SUBJECT Trinity Parkway Technical Proposal
(Conceptual Development of the Design Charrette Report)

Trinity Parkway Technical Proposal

(Conceptual Development of the Design Charrette Report)

Transportation and Trinity River Project Committee
March 21, 2016

Variation #3

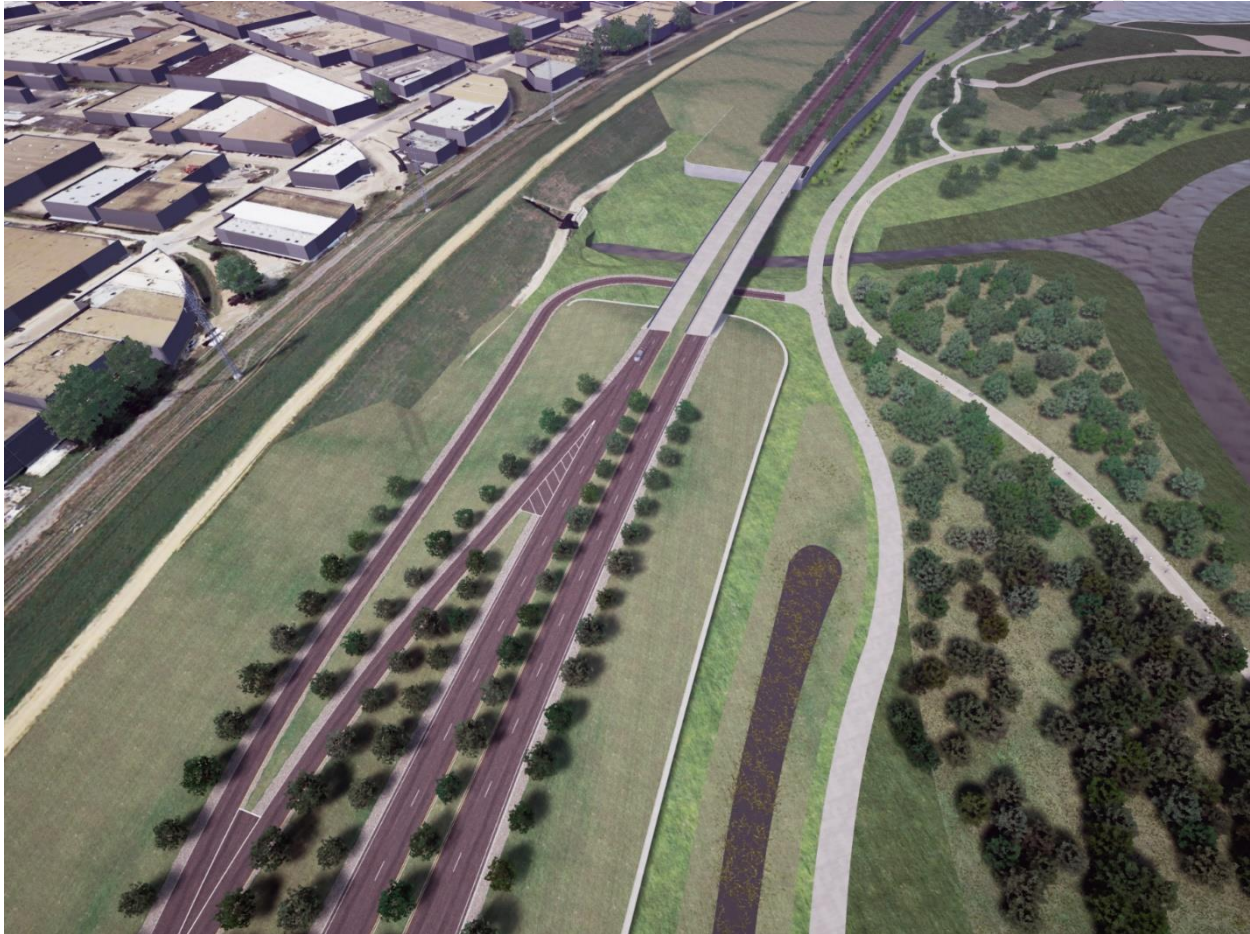
Ban trucks except for emergencies.

Discussion: The Technical Team discussed the typical approach to toll revenues, limited projected use by trucks, the possibility for providing higher tolls to reduce truck traffic, and an outright ban for non-emergency situations.

There is very little demand from trucks on tolled/managed lanes and trucks have alternative routes. The Design Charrette Team confirmed that a full ban is recommended. Ultimately, this is a management policy decision that does not appear to have a large impact on toll revenue. This can be achieved through an agreement between project partners.

Section M: North of Houston Street Viaduct looking South
1247+00

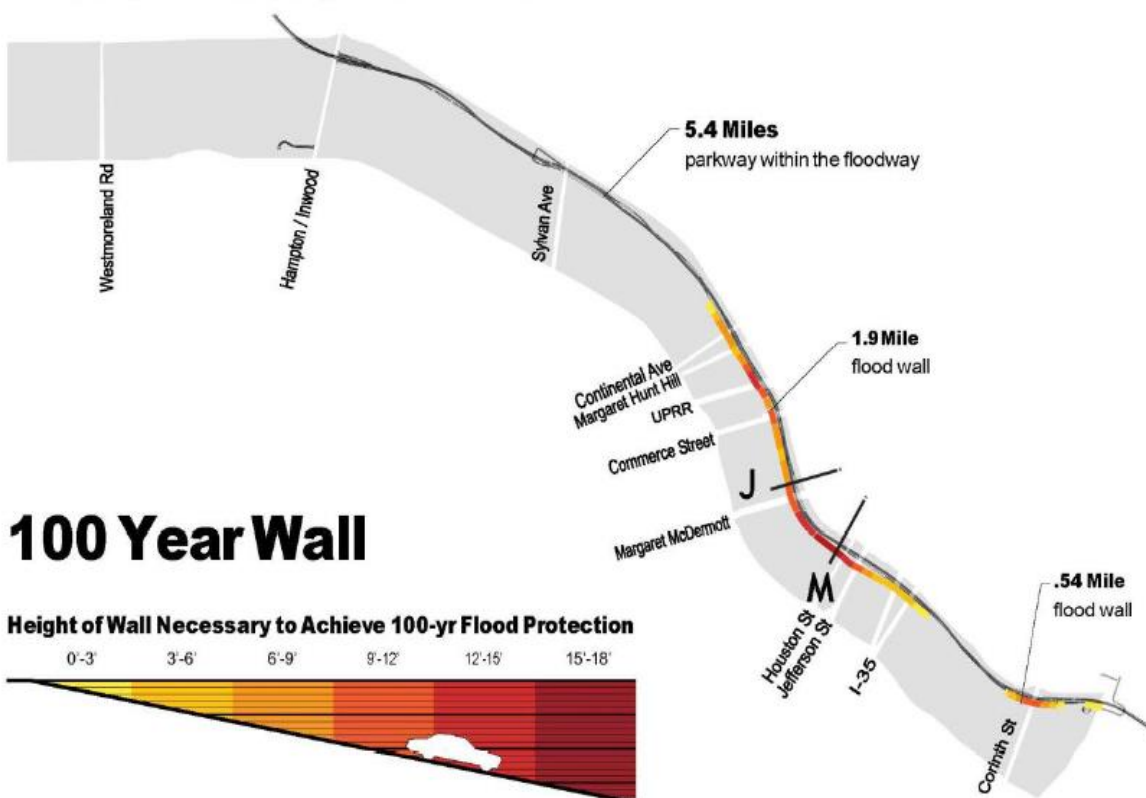
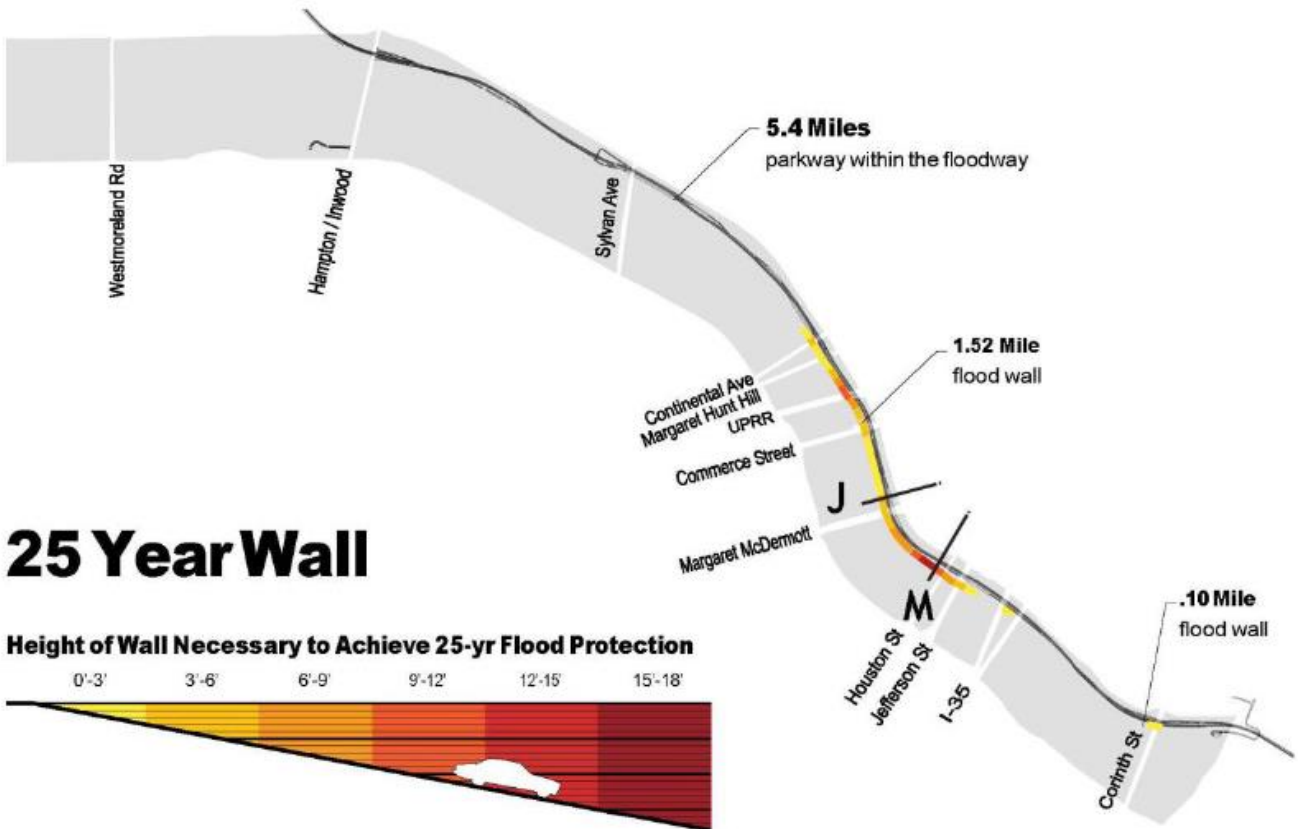
Design refinement of flood protection barriers with landscape, art, wall treatments and hillocks or berms to eliminate blank walls and secure more pervasive views of the park and to add character, interest, and a strong ecological strategy all along the Parkway.

However, up to 23-foot walls remain in a 2.25 mile stretch from Turtle Creek Outfall to the DART bridge on the park side, which cannot be confirmed for adjusted landscape or berm camouflage treatments until detailed park design is completed. The current federally approved BVP does include floodwall treatment with some levels of landscaping or other aesthetic features. It may be difficult to camouflage these park-side walls with berms in addition to or in lieu of landscaping. Design to a lesser flood standard was reviewed, which would open up views and make camouflaged berms easier on both sides of the wall, but this configuration opens the Parkway to more frequent flooding and lowering down to as low as 10-year flood protection only reduces the wall height by seven feet.

Technical Team Findings: Design exceptions will be required from the approved scheme to achieve berming on the Parkway side for the 100-year flood standard. Further detailing of this concept with landscape elements may be pursued during the 65%-level landscape design development. This will include further testing and review of the exact configuration of berms and hydrology to be consistent with the Corps' technical guidance.

Design Refinement #5

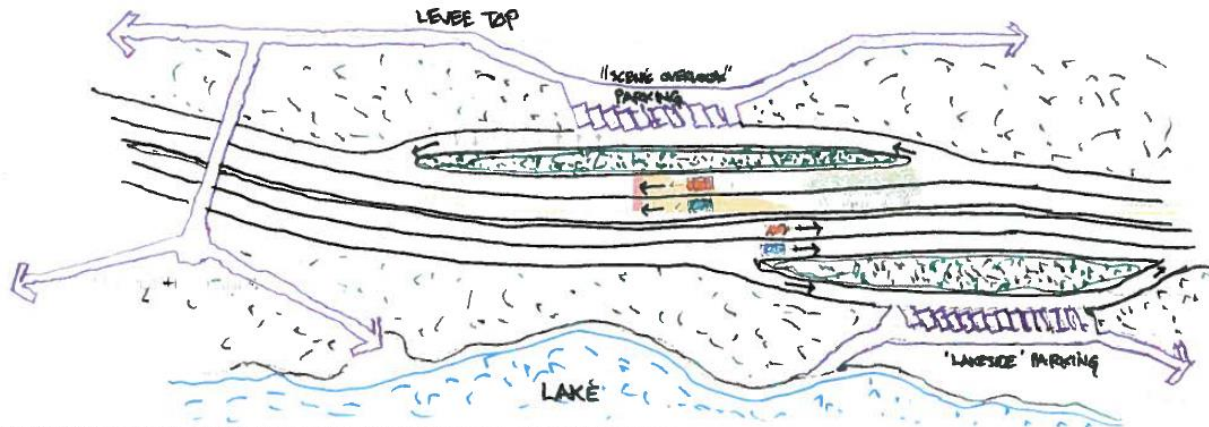
Design refinement to exploit five major “WOW” views over the Parkway.

Discussion: Only one “WOW” view does not have an opportunity to stop for a vehicle, but the other views offer several options to stop nearby. The Design Charrette Team confirmed that this slight change does not conflict with the Design Charrette Team vision because the key views are preserved, especially since the meanders are purposely oriented to exploit them.

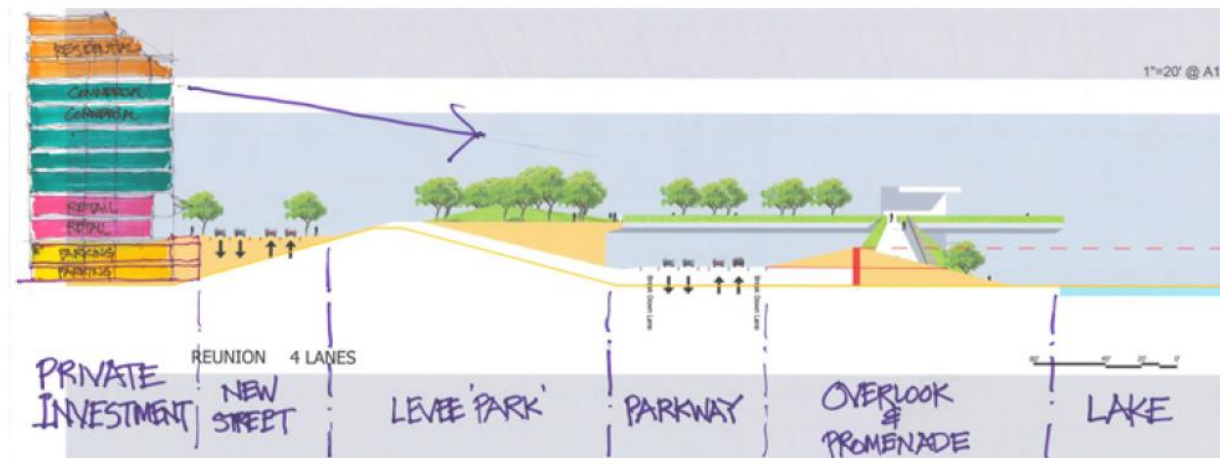
Locate transit stops so as to enhance transit-user access to the park over the Parkway – for example, provide a Houston Bridge streetcar stop and a Riverfront Boulevard bus stop.

Discussion: This idea requires more inquiry with the transit agencies, but it is not seen as a major problem to achieve either on the roadway bench in parking areas or in the floodway on a park road system.

Technical Team Findings: This opportunity is not ruled out by the current Technical Proposal. This should be resolved with further design.

Development Strategy #2

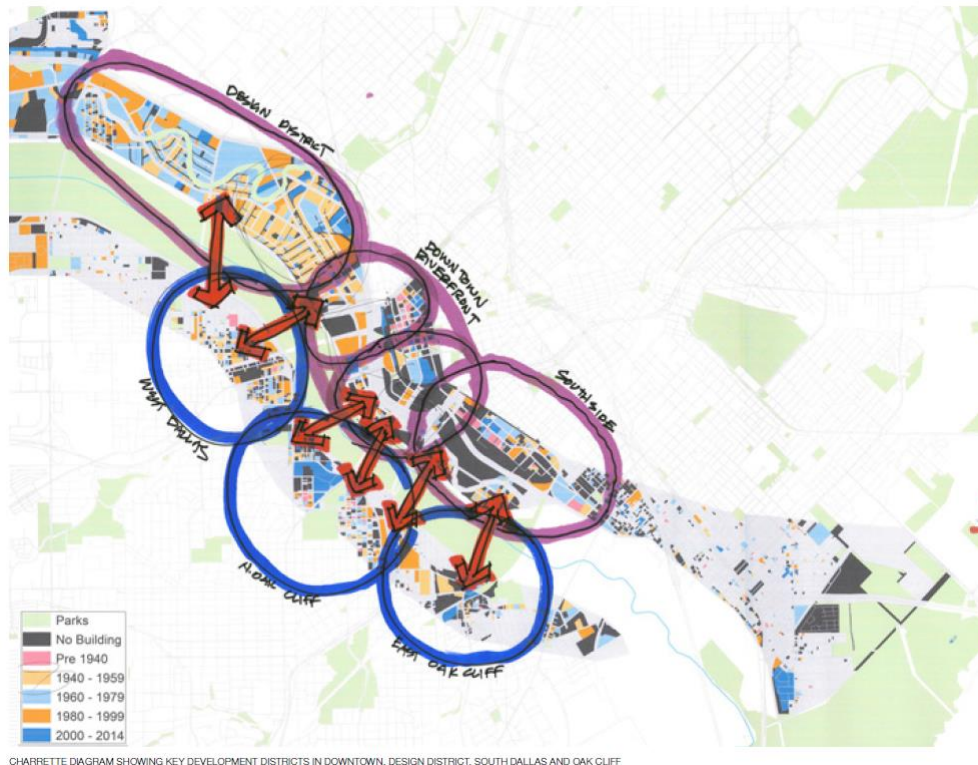
For the 'Design District', facilitate the current incremental development trend with regular and attractive pedestrian connections across the Parkway to the park.

Discussion: All existing pedestrian/bike links have been retained and the Technical Proposal can accommodate more pedestrian/bike links over time as determined in the further design review of the park or through private proposals. As many links as possible are desirable.

Development Strategy #3

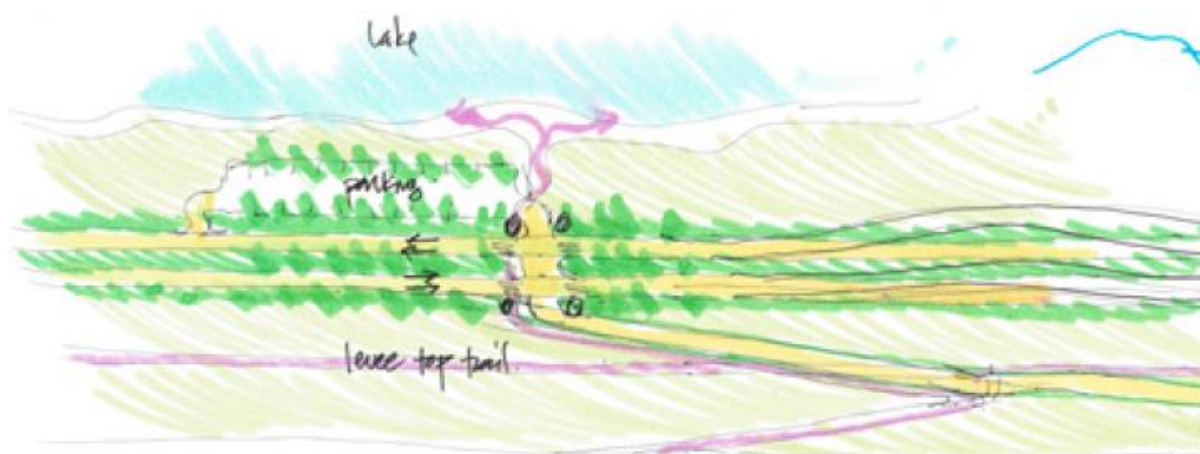
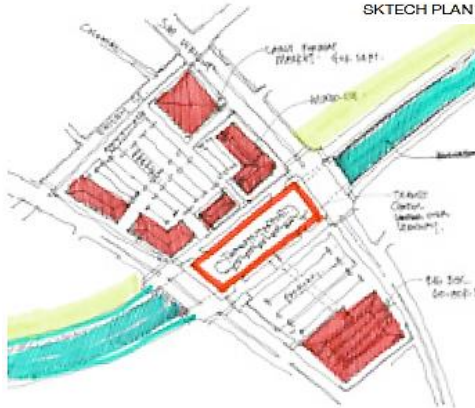
For the ‘Southside District’, facilitate the current development inclinations by enhancing the “sump” water bodies as the primary amenities – in this district the park and Parkway are less important.

Discussion: One possible ramp option, at Riverfront, would significantly diminish the economic development opportunity in the “Southside District” by crossing directly over the center of one of the sumps, potentially impacting flood management function and neutralizing its amenity potential to draw development. Further design development is underway to determine if the ramp can be reconfigured to move it away from the sump and resolve the problem.

Technical Team Findings: This development strategy requires further planning and design as noted above.

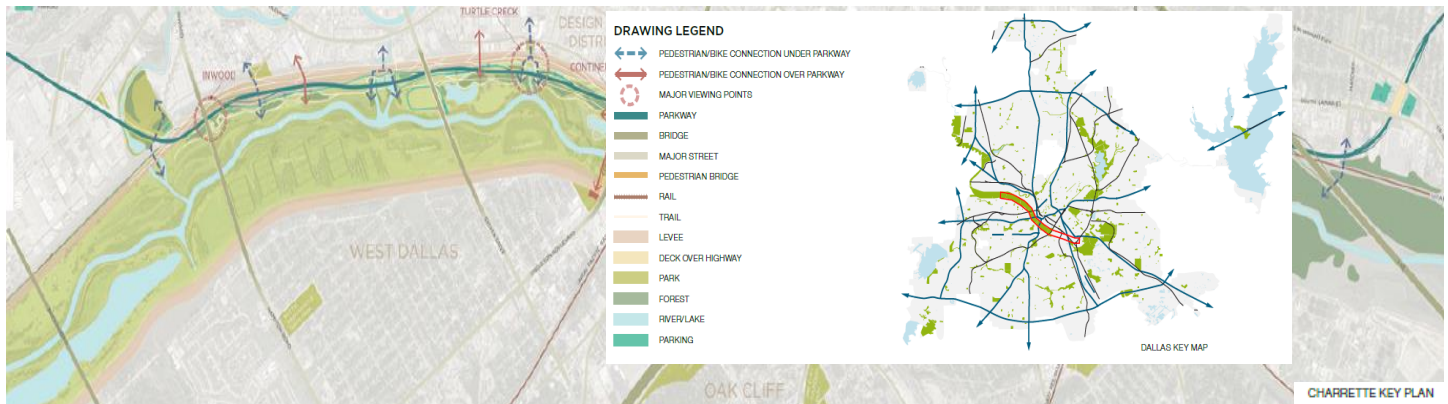
Discussion: The Design Charrette Team envisioned that the roadway design should not be targeted to a specific speed, but rather meet all quality expectations or 20 ideas of the Design Charrette Team vision. The Technical Proposal stays true to this principle, and in the end resulting in a design speed of 45 MPH for this initial phase. Increasing design speed to 55 MPH or 60 MPH would result in removal or smoothing out of most of the meanders and loss of over half of the pull-off parking opportunities, so it would be significantly incompatible with the Design Charrette Team vision.

Technical Team Findings: Evaluation suggests that the 45 MPH effective design speed, with the 4-lane cross-section, will cut the vehicle miles traveled in the regional model by about 40% from the ROD maximum estimate – however it still accommodates the projected demand in the near term as part of a phased plan.

Additional Consideration #3

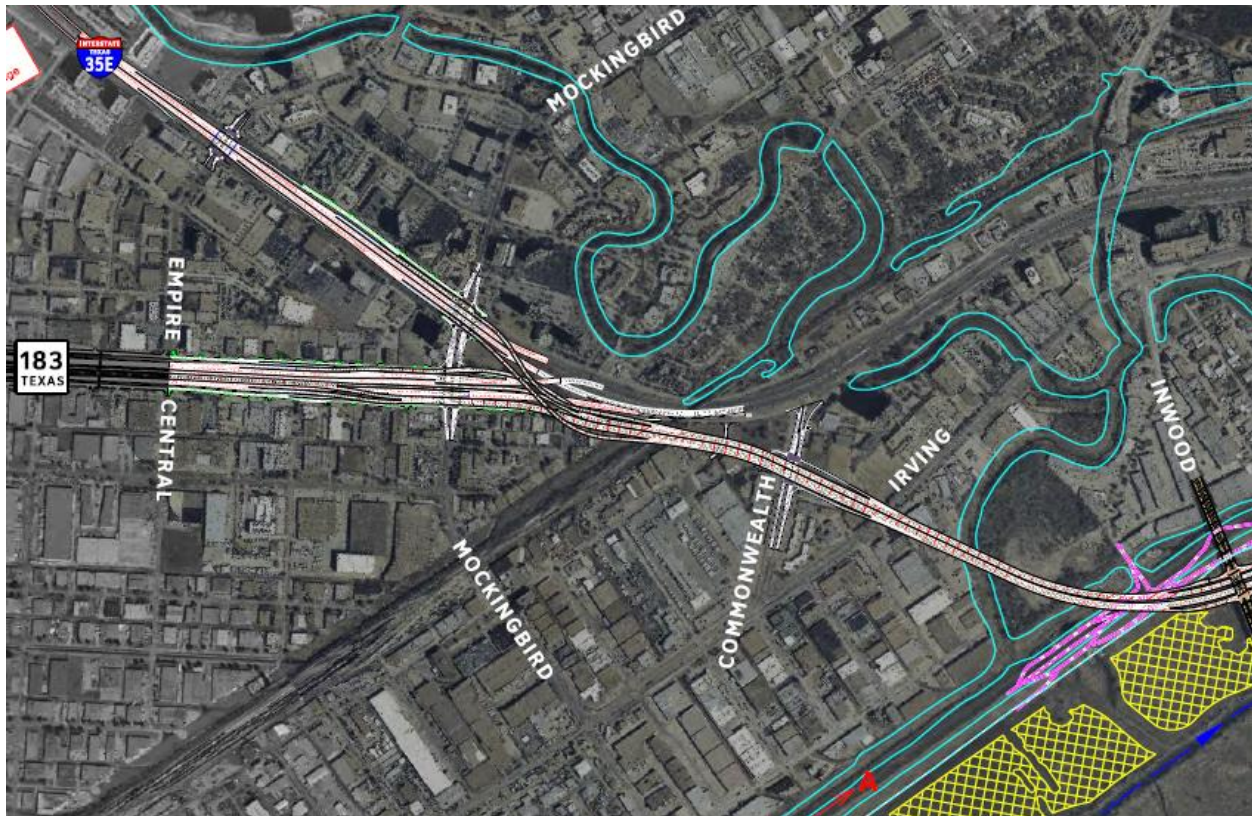
Economic Development of IH-35/SH-183 Connections.

Discussion: As noted earlier, the Design Charrette Team examined economic development ideas in the areas that immediately about the Parkway alignment between the IH-35 and IH-45 ramps. During the forum following the Design Charrette, several respondents raised questions concerning the potential for economic development in the area near the IH-35/SH-183 connections, in addition to the Southside/Lamar, Design District, and Reunion areas. While the economic activity within this area is currently industrial-based facilities, other types of economic development could be considered that would require appropriate planning and zoning.
